CABINET MEMBER FOR ENVIRONMENT – 12 OCTOBER 2017

PROPOSED REVISED WAITING RESTRICTIONS AND EXTENSION OF 20MPH SPEED LIMIT, A4144 WOODSTOCK ROAD BY THE RADLCIFFE OBSERVATORY QUARTER OXFORD

Report by Director for Infrastructure Delivery

Drawing Title: Preliminary Design
Revised General Layout

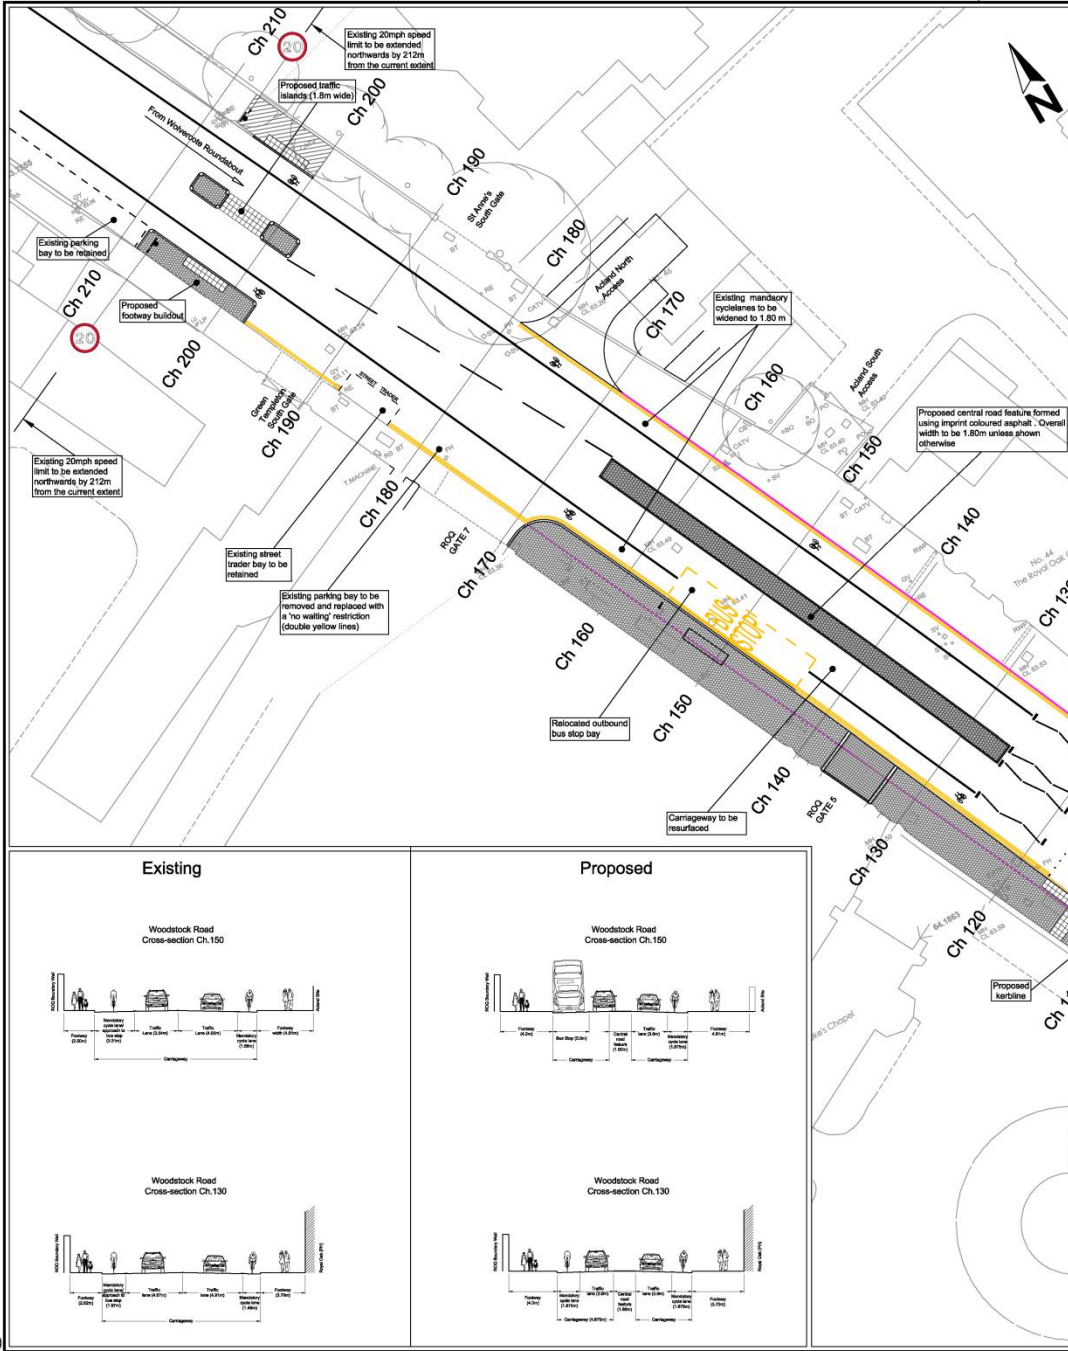
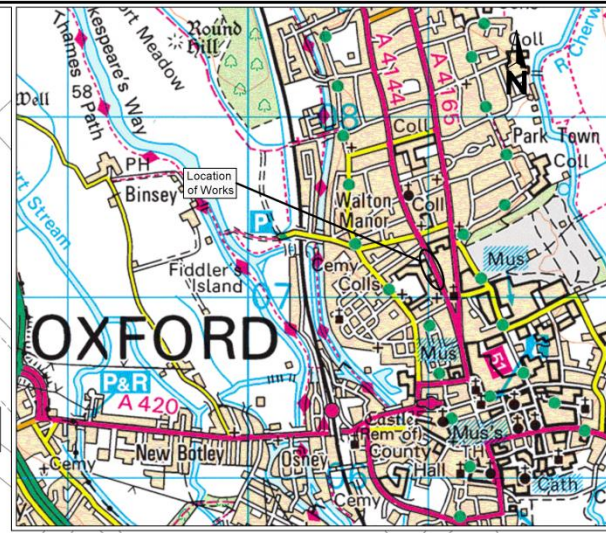
7. St Anne's College objected to the proposed reduction in the number of pay and display parking places on the grounds of the inconvenience that would result for visitors and contractors working at the college. The college also expressed concerns that the proposed paved median area could be mistaken by pedestrians as a providing a refuge, whereas in practice it will frequently be over-run, particularly by the bus stop, which the college suggested is relocated to a wider part of the road.

10. A member of the public - while also expressing support for the proposed 20mph speed limit and changes to the pay and display parking – also expressed very strong concerns about the effect of the scheme on cyclists, and specifically considered that the safety and amenity of cyclists would be adversely affected by the reduced width available due to the provision of the widened footway and central median area, particularly at the bus stops.

St Anne’s College	<p><u>20mph speed limit</u> – Support – <i>No comment.</i></p> <p><u>Parking restrictions</u> – Object – The reduction of parking opportunities for visitors to our college is unwelcome. Our contractors often use the P&D parking. On behalf of St Anne's College, I also object to the planned changes at Ch150. The northbound traffic will have to use the imprinted tarmac 'central reservation' to pass buses at the adjoining bus stop. You have, with your current plan, designed in a potential accident. Pedestrians will believe, by the nature of the coloured area that they are in some form of refuge. This, according to you plan will not be the case and could lead to confusion and potentially an accident. The only thing that mitigates is the 20 mph speed limit. The bus stop should be moved to a wider part of the road.</p>

<p>Cycle Super Route appear only partially upheld. We feel that there is a lost opportunity for segregation and bus-stop bypasses in this section. Generally the dimensions don't indicate a 20mph area and these could be visibly different, therefore supportive of 20mph driving, were the cycle provisions to be segregated: the road would then look, and be, narrower. Having a mandatory marked lane, with Double Yellow Lines at the kerb, rather negates the message about safe cycling which 'mandatory' markings should give.</p> <p><u>Parking restrictions</u> – Support – The wide area of Mandatory Lane at the Green Templeton College reads incoherently, it has a 'Street Trader' marked in it. It is an invitation for conflict. The Mandatory Lane should have an inner edge in an attempt to give it a recognisable, specific provision. The on-street parking north of Green Templeton College south gate, is another invitation to continue an existing conflict. We support the build-out as a physical marker for the car parking rather than enabling a driver to cross the cycle lane. There will be manoeuvring into parking places, but at least it will usually be at a lower speed. The Mandatory Lane should have an inner edge in an attempt to give it a recognisable, specific provision.</p>

<p>However, also expressed utter disappointment in the rest of the cycling facilities proposed in respect of the width of the cycle lanes, noting that it would be far preferable to remove the proposed median area provide more space for cyclists, particularly at the bus stop, where a cycle bypass could be considered. This design will absolutely mean cyclists remain constantly in conflicts with people driving vehicles. A conflict area where buses and cyclists have to cross paths at the bus stop is even built specifically into this design. Cyclists WILL get injured or worse because this city chose to waste money painting the middle of a road and widening pavement.</p>
<p>(21) Local Resident, (Watlington Road)</p>	<p><u>20mph speed limit</u> – Support – We support this project and consider it will be a positive addition to the public realm, We are particularly supportive of the use or imprint surfacing for the central road feature. We are keen to ensure a high quality bus stop with superior facilities that might be expected on a high quality bus corridor, including: -</p> <ul style="list-style-type: none"> • Good bus stop design including real time passenger information display, printed timetable and service information, local map and way finding; • High visibility bus stop flag and pole with appropriate and consistent branding; • An enhanced maintenance regime to maintain the quality feel of infrastructure investment; • A higher kerb to reduce the step height between the bus and the footway, minimum 125mm; • A stop cage marking of sufficient length to enable buses access close to the kerb. Minimum of 15m per bus if unobstructed (to cater for maximum likely vehicle lengths). <p><u>Parking restrictions</u> – Support – The removal of pay and display spaces at this location is essential to allow for the free flow of traffic, including buses through this scheme and accordingly this needs to be delivered to ensure a high quality scheme.</p>

15. The representations made on wider aspects of the design of the scheme - including the concerns expressed by St Anne's College on the safety of the scheme in respect of pedestrians, and Cyclox and a member of the public in respect of the provision for cyclists, and also the design of the bus stops are similarly noted. They do however lie outside the scope of the consultation, and it should be stressed that the design has been subject to very careful assessment on its impact on all road users; since the consultation was carried out, the design has been amended in a response to an independent road safety audit to;

- Remove the central median treatment,
 - Provide for surface colouring at the formal and informal crossing locations of the scheme,
 - Widen the mandatory cycle lanes, and also

- To slightly amend the zig zag markings at the puffin crossing.

- Proposed relocation of the bus stops. Positioning of the bus stops has been carefully considered in the design. Due to the need to maintain access to existing facilities, an alternative positioning of the bus stops would mean that an alternative location for these popular stops would be located away from the areas of passenger demand. Additional walking required to any relocated stops would likely inconvenience the majority of current/ future passengers utilising these stops.

- Potential design conflict points for cyclists at where parking bays are located by the Green Templeton College entrance. Officers acknowledge the comments and suggestions made and will consider suitable options for addressing these points as part of further scheme design.

- Provision of cycle bus-stop bypasses and segregated cycle lanes. Provision of either design feature was not considered appropriate to the location due to the frequent number of vehicle access and egress points along the scheme. Officers consider that this would compromise the integrity of any segregated cycle provision.
